Schedule of Modifications

City of South Perth – Proposed Scheme Amendment No. 61 to Town Planning Scheme No. 6

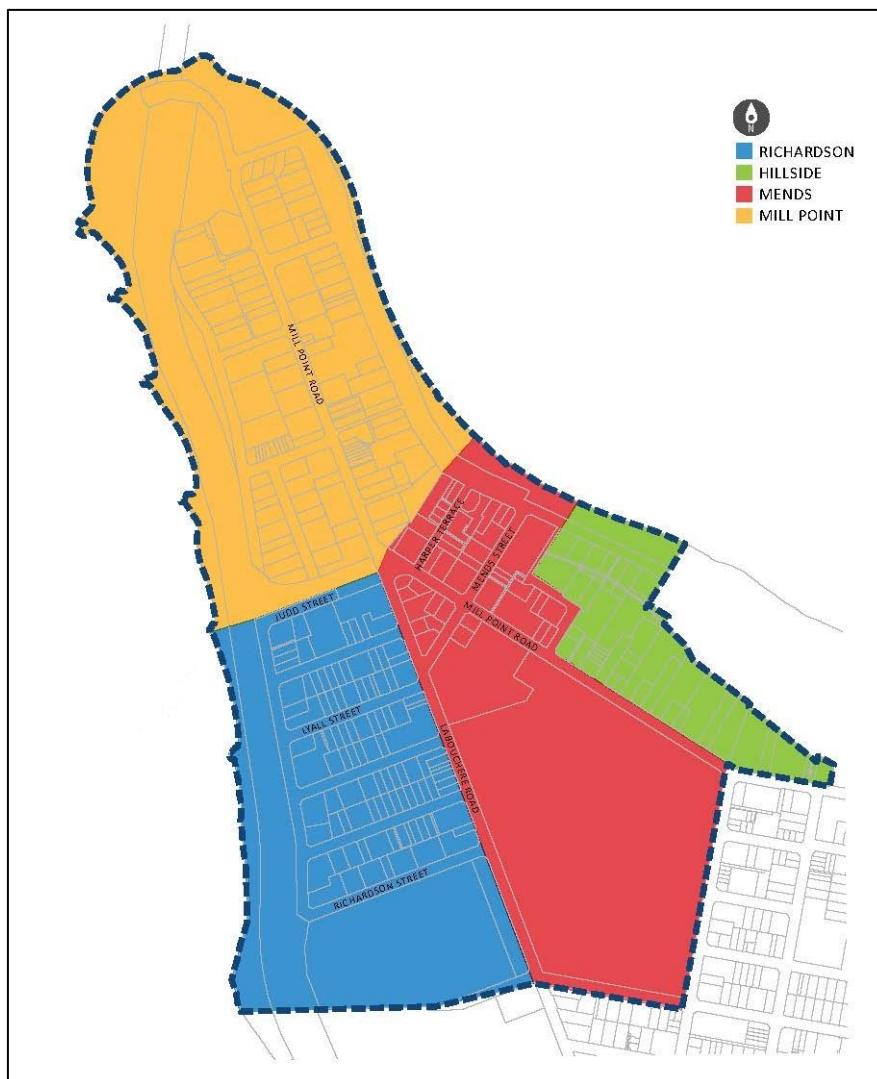
1. Modify Map 1 to remove unnecessary detail from the underlying cadastral map and depict the boundary between the Mends and Hillside Character Areas to follow Darley Street, Ray Street and the laneway separating Lots 113 (No. 81-85) and 36 (No. 87) South Perth Esplanade as per the following map:

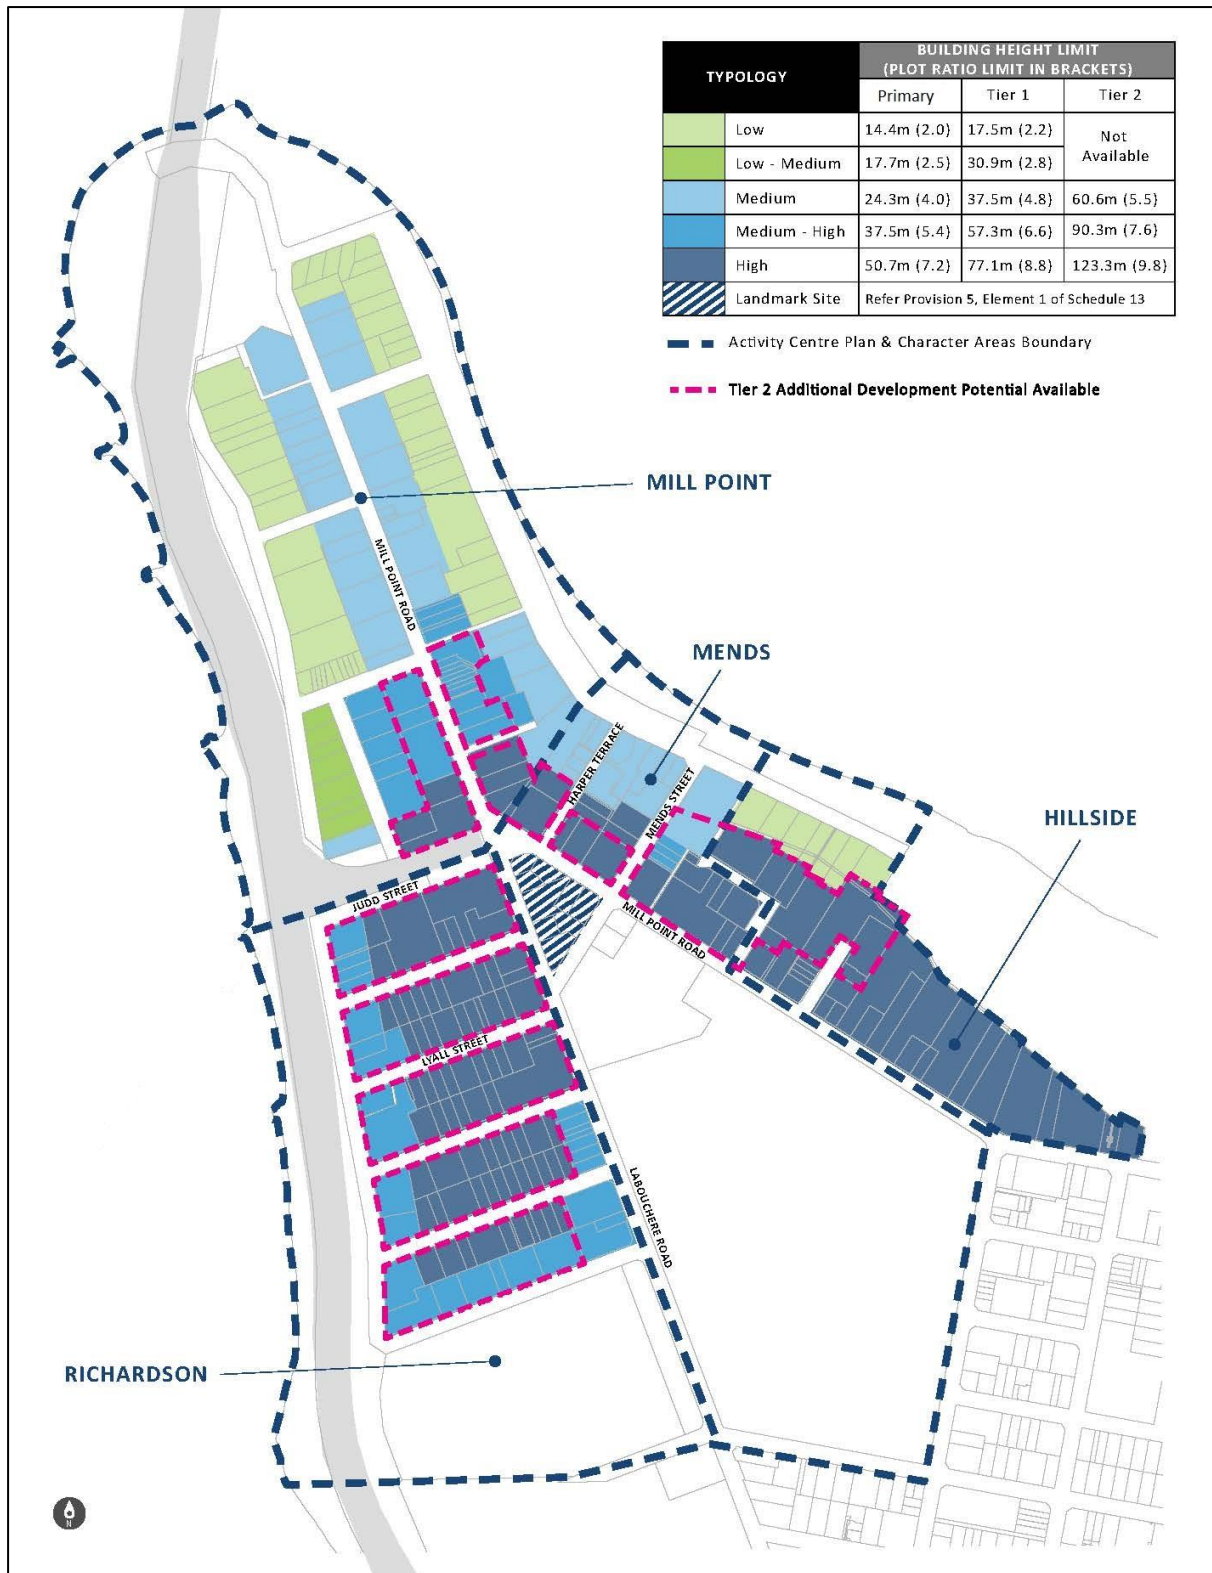
11. Modify Map 2 to depict:
 - (a) Remove unnecessary detail from the underlying cadastral map;
 - (b) The words “Height Type” in the legend changed to “Typology”;

- (c) The word “Base” in the legend changed to “Primary”;
 - (d) The orange dashed line showing “Tier 2 Additional Development Potential Available” as a pink dashed line;

- (e) Lots fronting Mill Point Road on the western side of Mill Point Road and north of Scott Street changed from the Medium-High to the Medium typology;

- (f) Lots fronting Mill Point Road on the eastern side of Mill Point Road and between Lot 102 (No. 14) Mill Point Road and Lot 35 (No. 62) Mill Point Road, inclusive, changed from the Medium-High to the Medium typology;

- (g) Lot 113 (No. 81-85) South Perth Esplanade as having Tier 2 Additional Development Potential Available on the southern part of the lot only;
 - (h) The boundary between the Mends and Hillside Character Areas to follow Darley Street, Ray Street and the laneway separating Lots 113 (No. 81-85) and 36 (No. 87) South Perth Esplanade;

- (i) The entirety of Lots 29 (No. 93), 30 (No.95), 31 (No. 97) and 100 (No. 99) South Perth Esplanade as Low typology;
 - (j) The entirety of Lot 501 (No. 9) Parker Street as High typology;

- (k) All lots in the Hillside character area fronting Mill Point Road or Parker Street changed from the Medium-High to the High typology.

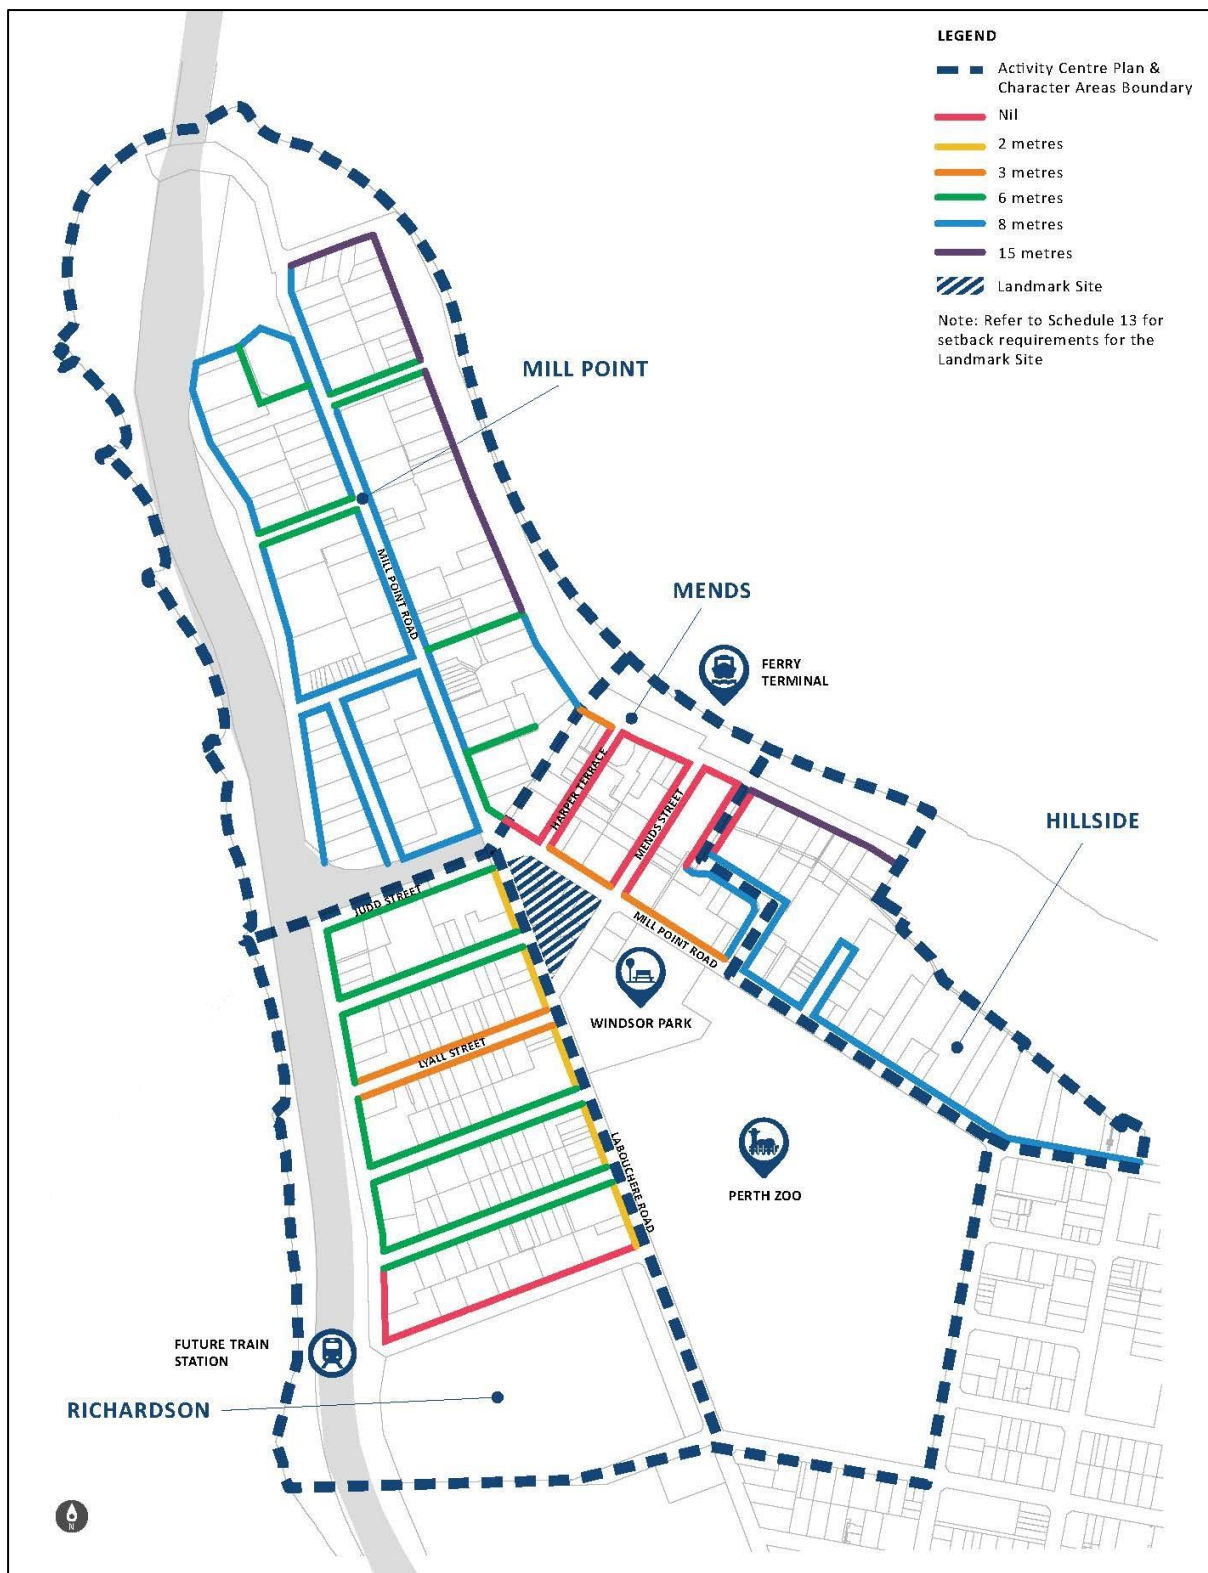
15. Replace Map 3 with a new Map 3 to depict Base Street Setbacks. The following locations have a modified base street setback:
- (a) The northern boundary of Lot 50 (No. 23) Mill Point Road with an 8 metre setback;

- (b) Lots 36 (No. 49), 101 (No. 51), 2 (No. 53) and 77 (No. 59) South Perth Esplanade, and Lot 501 (No. 5) Ferry Street with an 8 metre setback to South Perth Esplanade;

- (c) Lots 2 (No. 86), 15 (No. 88) and 16 (No. 90) Mill Point Road with a 6 metre setback to Mill Point Road;
 - (d) Remove the indication of a street setback from the southern portion of Lot 11 Stone Street (Stone Street Reserve)

- (e) Lot 1 (No.s 1 and 5) Harper Terrace with a nil setback to Mill Point Road;
 - (f) All lots fronting Ray and Darley Streets with an 8 metre setback to Ray and Darley Streets;

- (g) All lots fronting Mill Point Road east of Darley Street with an 8 metre setback to Mill Point Road;
 - (h) All lots fronting Judd Street with a 6 metre setback to Judd Street;

- (i) All lots fronting Melville Parade between Judd Street and Charles Street with a 6 metre setback to Melville Parade;
 - (j) All lots fronting Lyall Street with a 3 metre setback to Lyall Street.

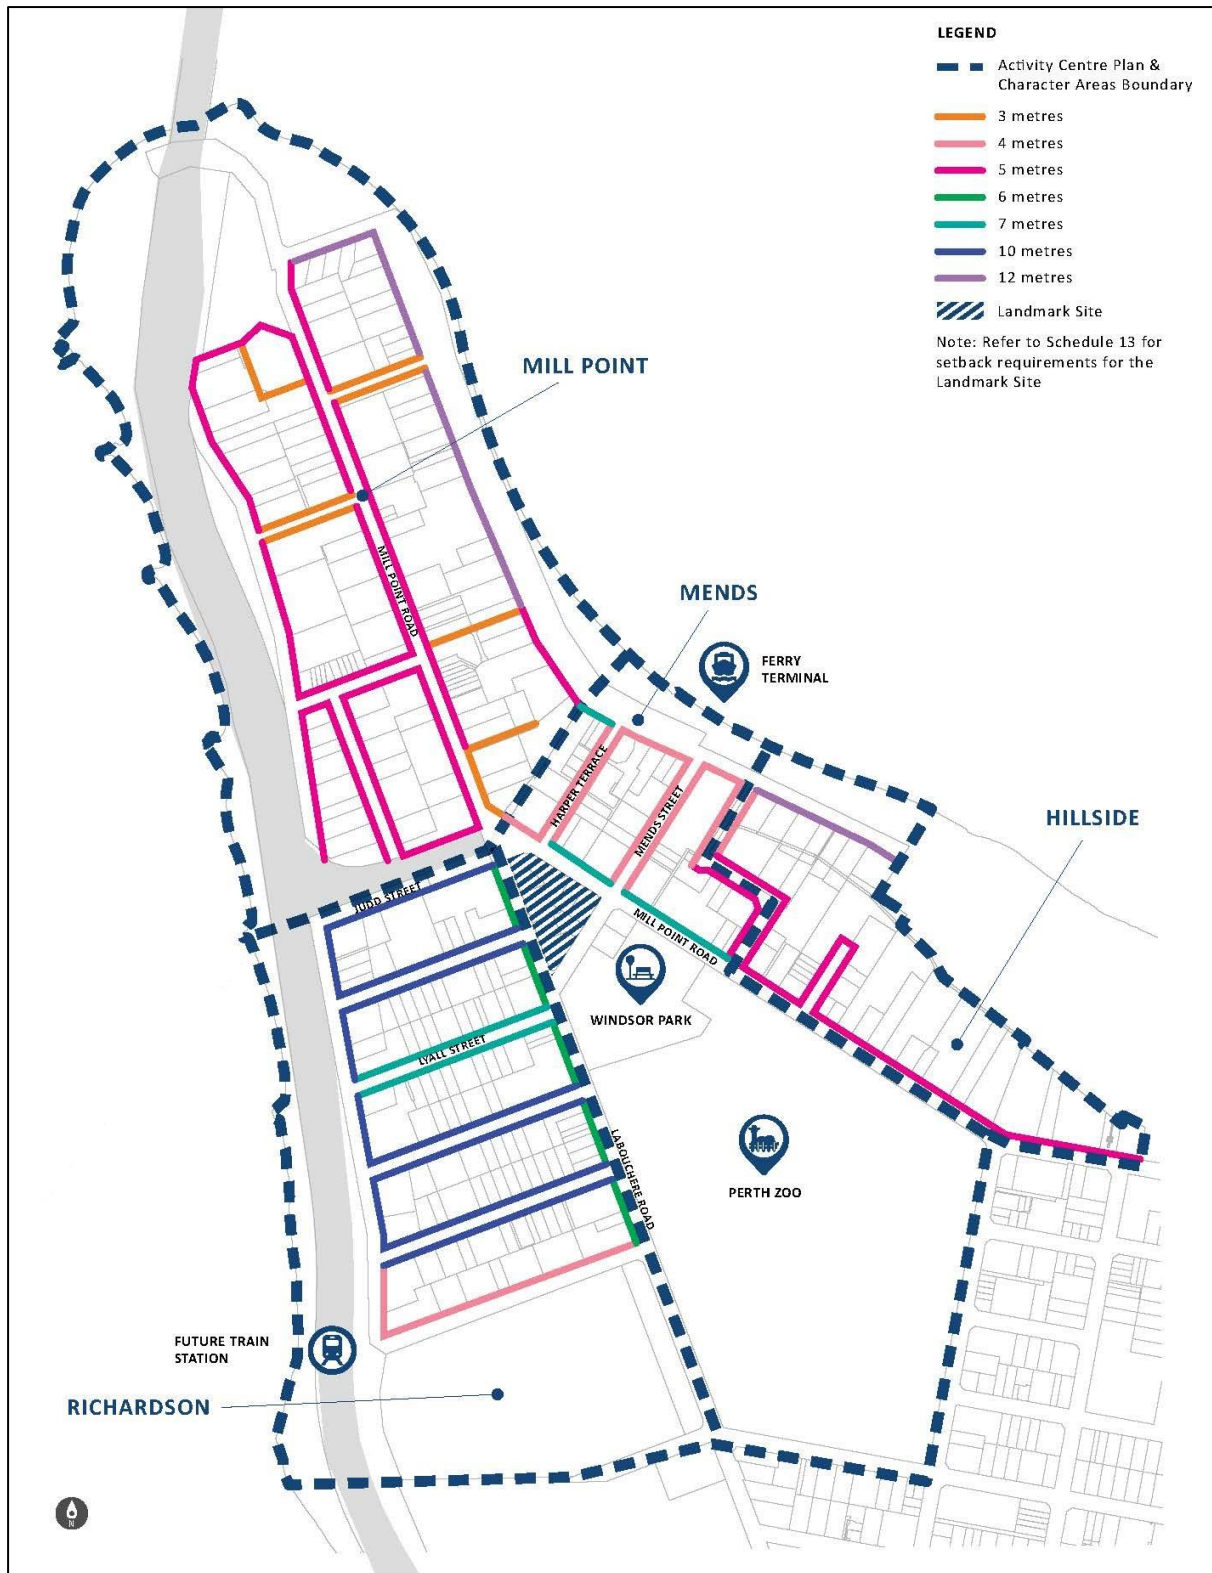
19. Add a new Map 4 to depict Tower Street Setbacks. The following locations have a modified tower street setback:
- (a) The northern boundary of Lot 50 (No. 23) Mill Point Road with an 5 metre setback;

- (b) Lots 36 (No. 49), 101 (No. 51), 2 (No. 53) and 77 (No. 59) South Perth Esplanade, and Lot 501 (No. 5) Ferry Street with a 5 metre setback to South Perth Esplanade;

- (c) Lots 2 (No. 86), 15 (No. 88) and 16 (No. 90) Mill Point Road with a 3 metre setback to Mill Point Road;
 - (d) Remove the indication of a street setback from the southern portion of Lot 11 Stone Street (Stone Street Reserve)

- (e) Lot 1 (No.s 1 and 5) Harper Terrace with a 4 metre setback to Mill Point Road;
 - (f) All lots fronting Ray and Darley Streets with a 5 metre setback to Ray and Darley Streets;

- (g) All lots fronting Mill Point Road east of Darley Street with a 5 metre setback to Mill Point Road;
 - (h) All lots fronting Judd Street with a 10 metre setback to Judd Street;

- (i) All lots fronting Melville Parade between Judd Street and Charles Street with a 10 metre setback to Melville Parade;
 - (j) All lots fronting Lyall Street with a 7 metre setback to Lyall Street.
